Cambridge Civic Quarter

RIBA Stage 2 Fire Strategy Report - Guildhall

P04

07/11/2024

Drawing Title
Proposed Second Floor Plan

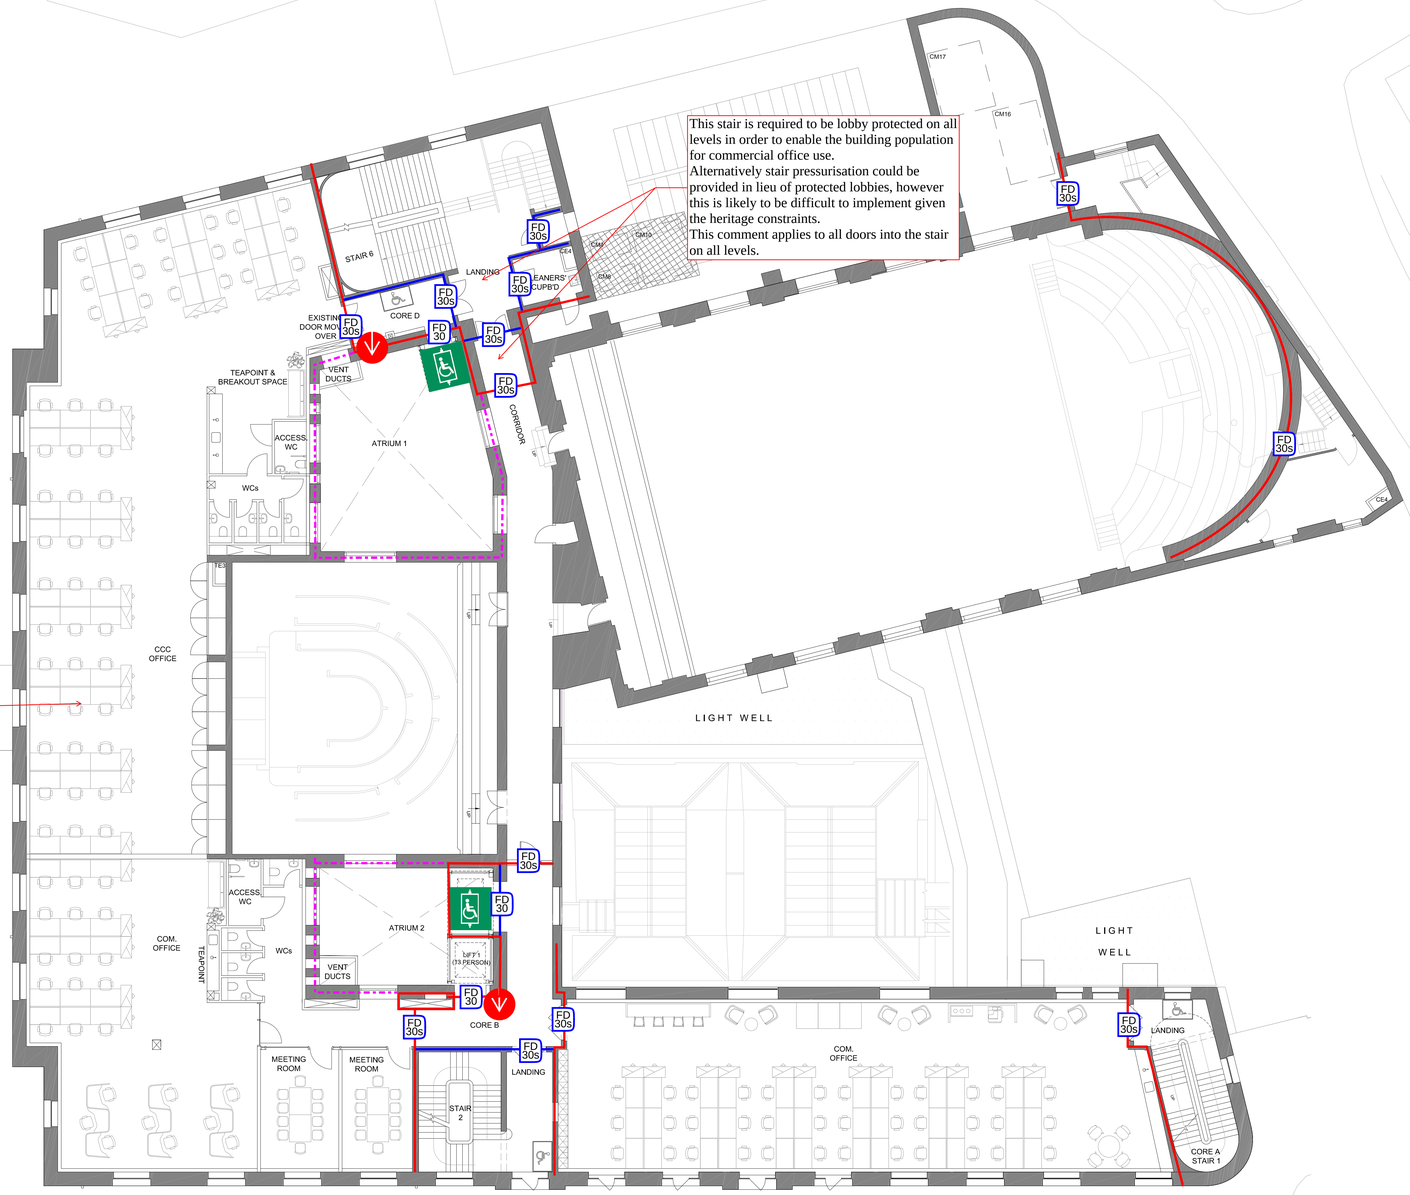
This stair is required to be lobby protected on all levels in order to enable the building population for commercial office use.
Alternatively stair pressurisation could be provided in lieu of protected lobbies, however this is likely to be difficult to implement given the heritage constraints.
This comment applies to all doors into the stair on all levels.

Office on upper levels
It is assumed that each office space on the North elevation forms a single lease space. If the desire is to split these, the means of escape will need to be required as separate occupancies cannot pass through an adjacent occupancy to escape. Where this is required to reach a stair, this should be via a protected corridor. This will cause a decrease to the amount of lease space on each level if added.

Drawing Title
Proposed Third Floor Plan

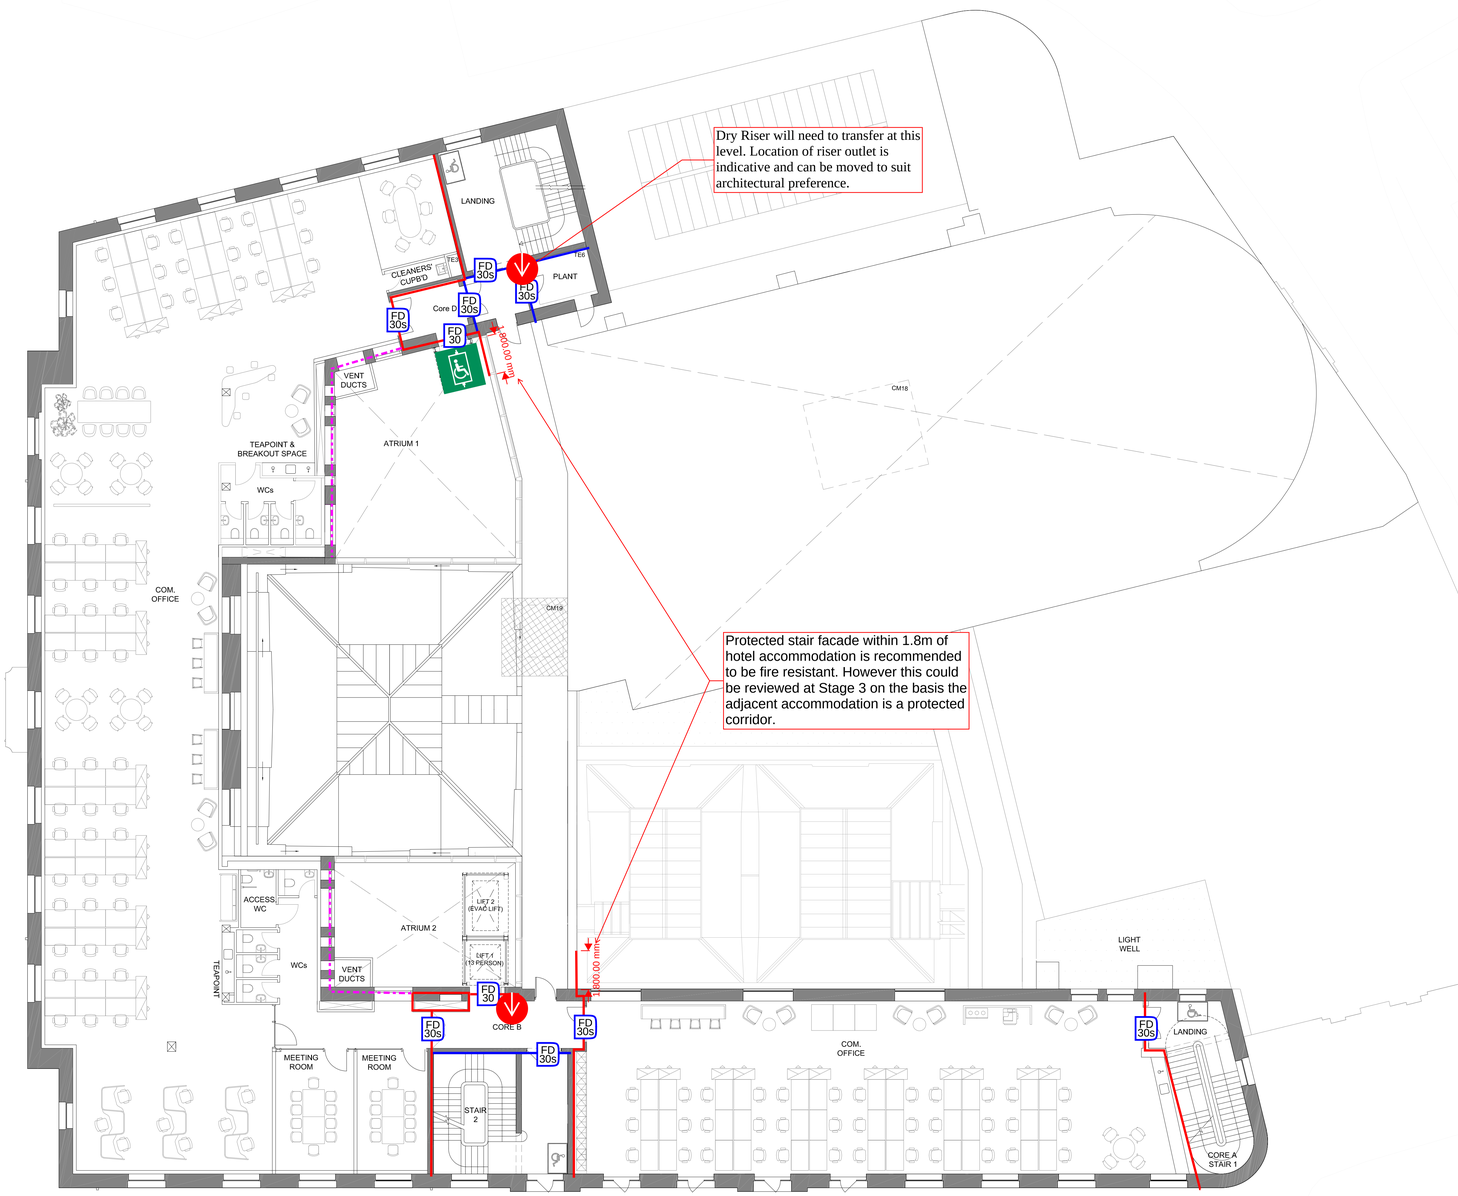
Dry Riser will need to transfer at this level. Location of riser outlet is indicative and can be moved to suit architectural preference.

Protected stair facade within 1.8m of hotel accommodation is recommended to be fire resistant. However this could be reviewed at Stage 3 on the basis the adjacent accommodation is a protected corridor.

Drawing Title
Proposed Fourth Floor Plan

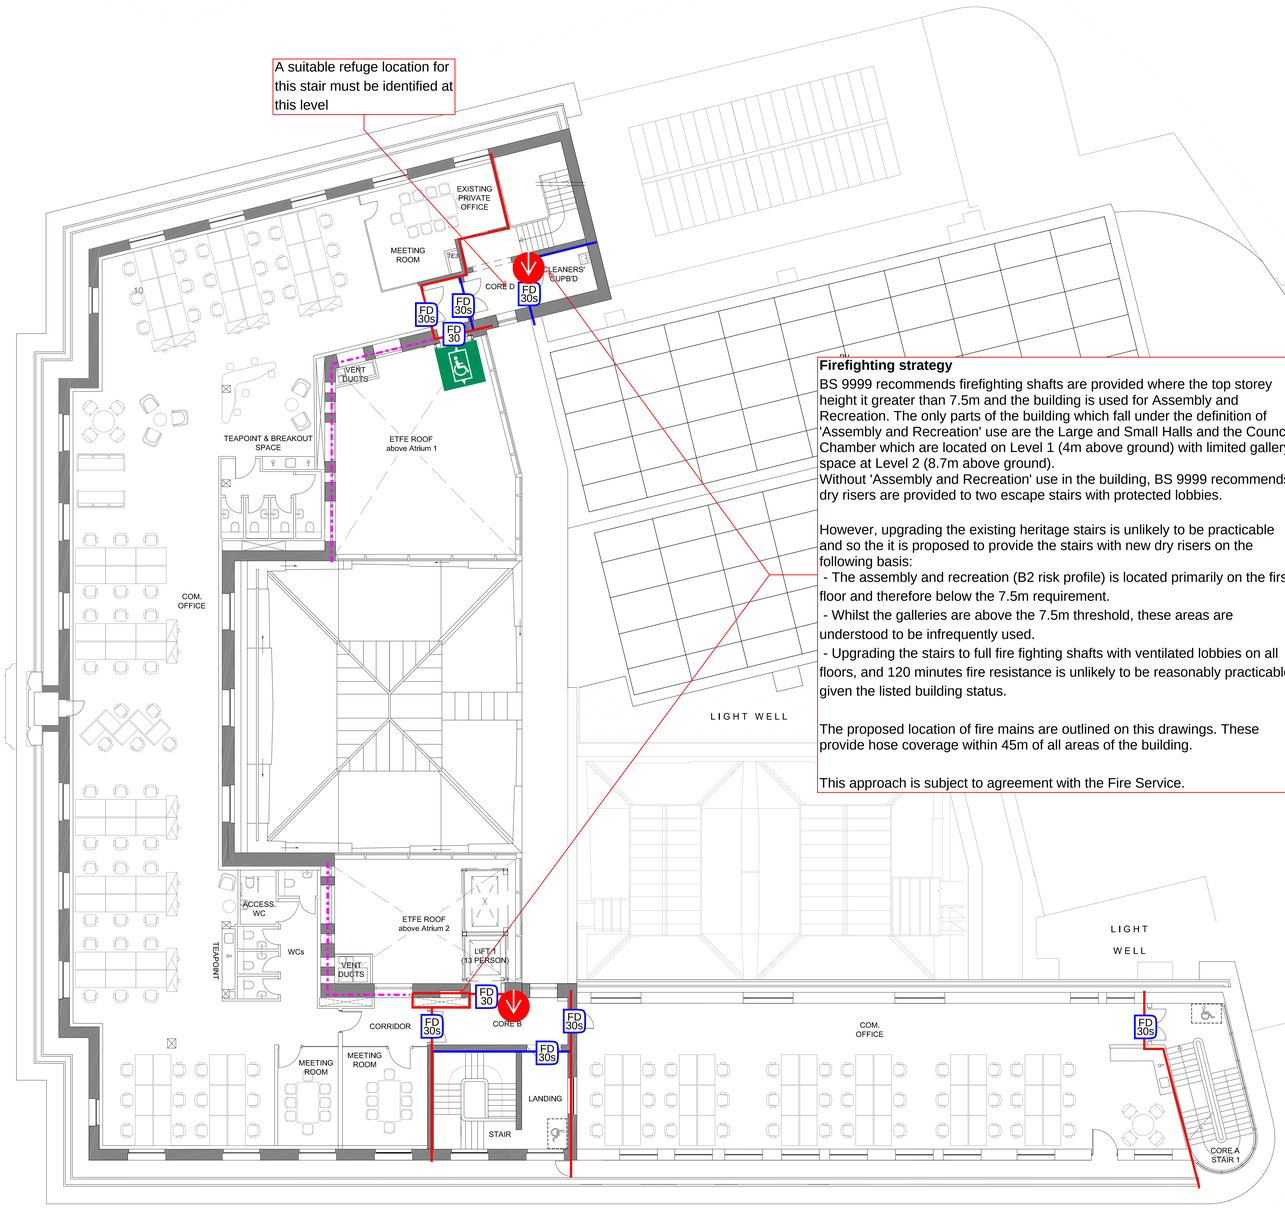
Firefighting strategy

BS 9999 recommends firefighting shafts are provided where the top storey height it greater than 7.5m and the building is used for Assembly and Recreation. The only parts of the building which fall under the definition of 'Assembly and Recreation' use are the Large and Small Halls and the Council Chamber which are located on Level 1 (4m above ground) with limited gallery space at Level 2 (8.7m above ground).
Without 'Assembly and Recreation' use in the building, BS 9999 recommends dry risers are provided to two escape stairs with protected lobbies.

However, upgrading the existing heritage stairs is unlikely to be practicable and so the it is proposed to provide the stairs with new dry risers on the following basis:
- The assembly and recreation (B2 risk profile) is located primarily on the first floor and therefore below the 7.5m requirement.
- Whilst the galleries are above the 7.5m threshold, these areas are understood to be infrequently used.
- Upgrading the stairs to full fire fighting shafts with ventilated lobbies on all floors, and 120 minutes fire resistance is unlikely to be reasonably practicable given the listed building status.

The proposed location of fire mains are outlined on this drawings. These provide hose coverage within 45m of all areas of the building.

Drawing Title
Proposed Third Floor Plan

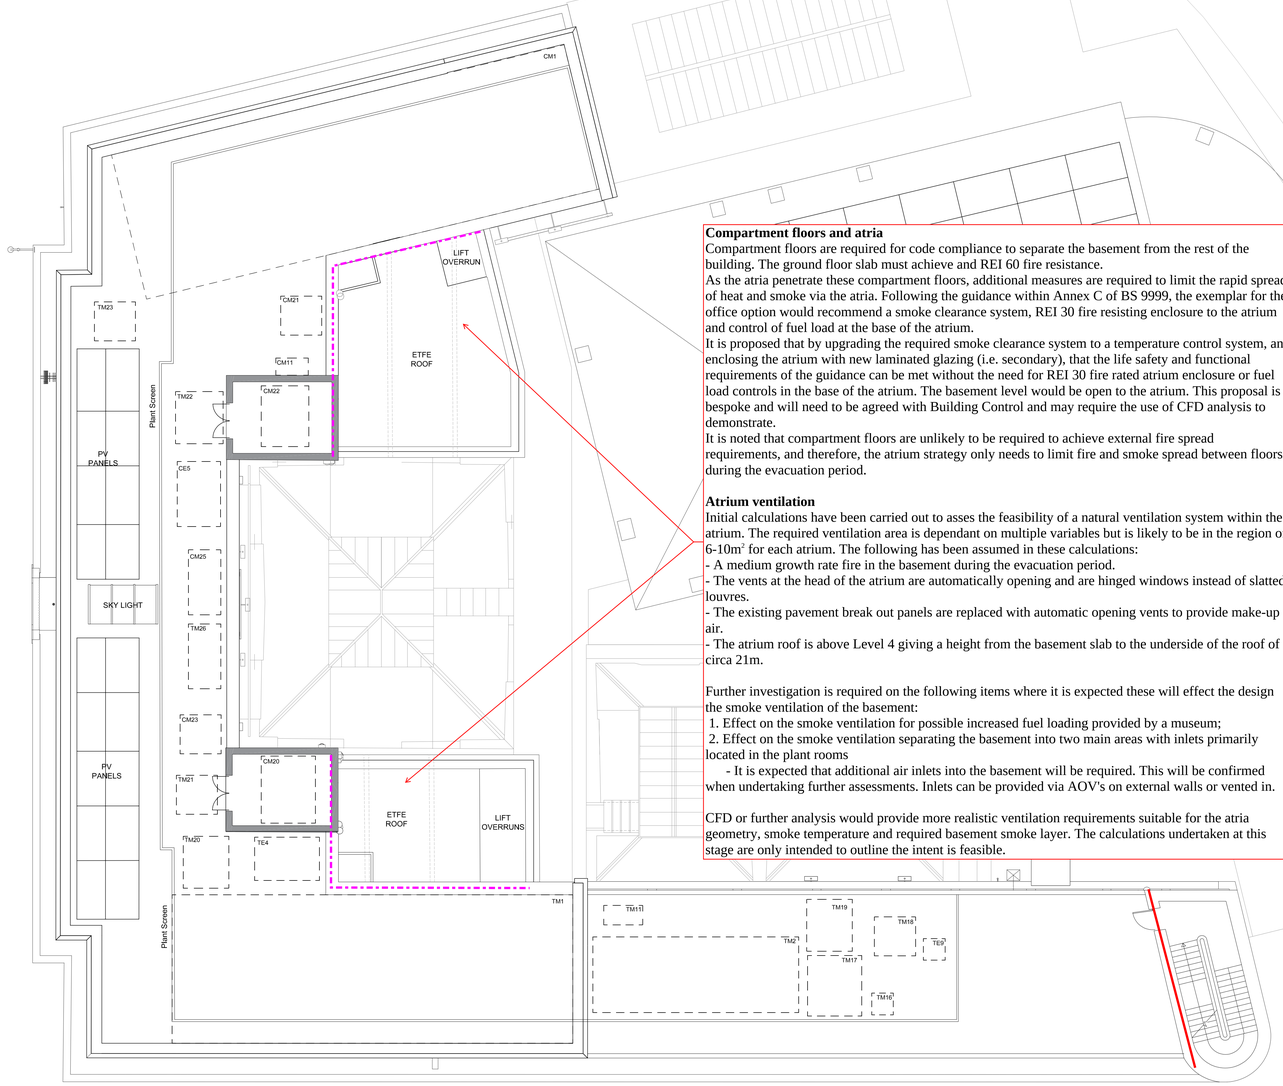
Compartment floors and atria
Compartment floors are required for code compliance to separate the basement from the rest of the building. The ground floor slab must achieve and REI 60 fire resistance.
As the atria penetrate these compartment floors, additional measures are required to limit the rapid spread of heat and smoke via the atria. Following the guidance within Annex C of BS 9999, the exemplar for the office option would recommend a smoke clearance system, REI 30 fire resisting enclosure to the atrium and control of fuel load at the base of the atrium.
It is proposed that by upgrading the required smoke clearance system to a temperature control system, and enclosing the atrium with new laminated glazing (i.e. secondary), that the life safety and functional requirements of the guidance can be met without the need for REI 30 fire rated atrium enclosure or fuel load controls in the base of the atrium. The basement level would be open to the atrium. This proposal is bespoke and will need to be agreed with Building Control and may require the use of CFD analysis to demonstrate.

It is noted that compartment floors are unlikely to be required to achieve external fire spread requirements, and therefore, the atrium strategy only needs to limit fire and smoke spread between floors during the evacuation period.

Further investigation is required on the following items where it is expected these will effect the design the smoke ventilation of the basement:
1. Effect on the smoke ventilation for possible increased fuel loading provided by a museum;
2. Effect on the smoke ventilation separating the basement into two main areas with inlets primarily located in the plant rooms
   - It is expected that additional air inlets into the basement will be required. This will be confirmed when undertaking further assessments. Inlets can be provided via AOV's on external walls or vented in.

CFD or further analysis would provide more realistic ventilation requirements suitable for the atria geometry, smoke temperature and required basement smoke layer. The calculations undertaken at this stage are only intended to outline the intent is feasible.
